31 October 2024

Illawarra Coal Holdings Pty Ltd
Port Kembla Coal Terminal, Inner Harbour
Port Kembla Road, Port Kembla NSW 2505

Dendrobium Mine Groundwater Flow Model Peer Review Findings

Figure 4.1 Conceptual model of groundwater and associated effects (Watershed Hydroeo, 2024)

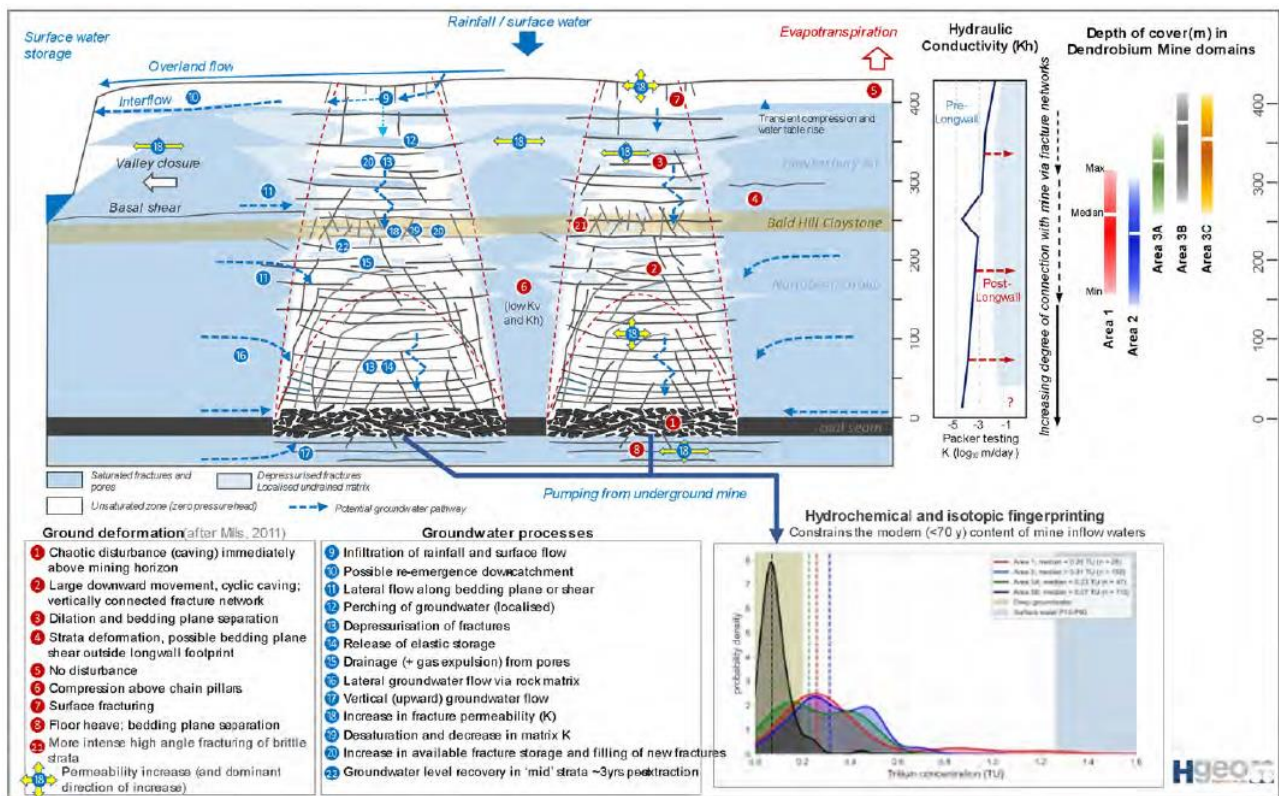
For instance the groundwater level data set used for model calibration includes data for around 1,200 deep groundwater level monitoring points. Data are also available for a further 120 shallow swamp piezometers and 32 surface water flow and level monitoring points, 16 of which are above historic longwall panels and have been used for calibration of modelled losses. The data from these monitoring networks is also complemented by extensive site characterisation activities which, for instance, includes data for some 3,400 pre-mining packer tests and further post mining packer testing above longwall panels 6, 7, 9 and 12 to 18. Based on this information a detailed conceptualisation of the area has been developed (Figure 4.1).

Importantly many of the key components of this conceptual model have been validated and/or measured using site data. For example as shown in Figure 4.2 the availability of downhole geophysics, pre and post longwall mining packer testing profiles and data for nested VWP arrays has allowed detailed before and after vertical profiles of actual hydraulic parameter changes and groundwater pressure responses to be developed for multiple longwall panels. The conceptual model and mechanisms by which impacts occur at the site are therefore well understood and confirmed in most cases by field data collection. As such the conceptual model presented is considered to be consistent with the model objectives and target high model complexity (or confidence level class).

Figure 4.3 Workflow to integrate data and to achieve modelling objectives (Watershed HydroGeo, 2024)

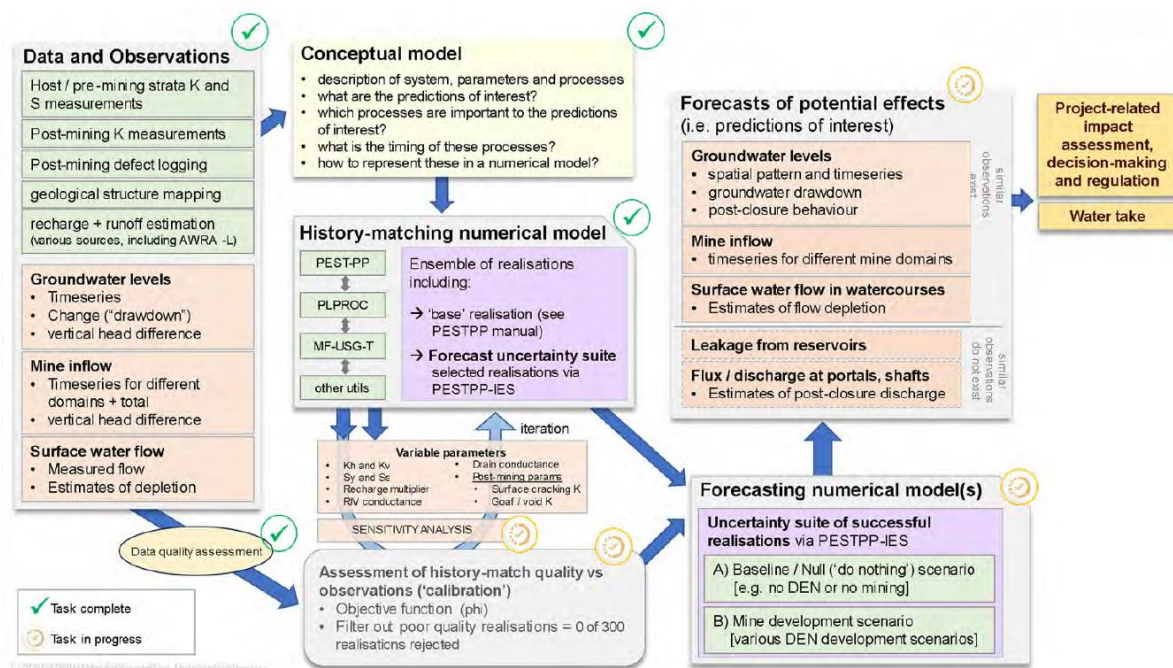
In almost all respects the numerical model design and modelling workflow (Figure 4.3) conforms with best practice. Modelling has been undertaken using MODFLOW-USG, using an appropriately designed mesh and calibration is to be undertaken through reference to both groundwater levels and flows and using software and approaches which are consistent with current industry standards. However, the overall size of the model and the associated very long run times are likely to represent a significant barrier to the degree to which: model parameters can be optimised during calibration (or history matching); or the sensitivity of key predictions to parametric uncertainty can be assessed.

Recent publications released as part of the Groundwater Modelling Decision Support Initiative (GMDSI) including Doherty and Moore (2021) stress that the primary task of a decision support groundwater flow model, such as the Dendrobium model, is the harvesting of information relating to highly complex sub-surface processes which can only be approximated in any numerical model. In this case the vast majority of this information relates to the Dendrobium Mine area and immediate surrounds (i.e. a small part of the current model domain). Furthermore, the primary potential impact pathways and receptors also occur in close proximity to the mine. It is recommended therefore that calibration is undertaken initially through the development of a smaller surrogate or nested model of the mining area itself. Such a model would run substantially quicker than the current regional model thereby improving the degree to which potentially spatial variability can be explored and parameters optimised (especially those representing subsidence fracturing processes). Once optimised, using the surrogate or nested model, parameters could be fed back into the current regional model in order to assess regional scale and cumulative impacts.
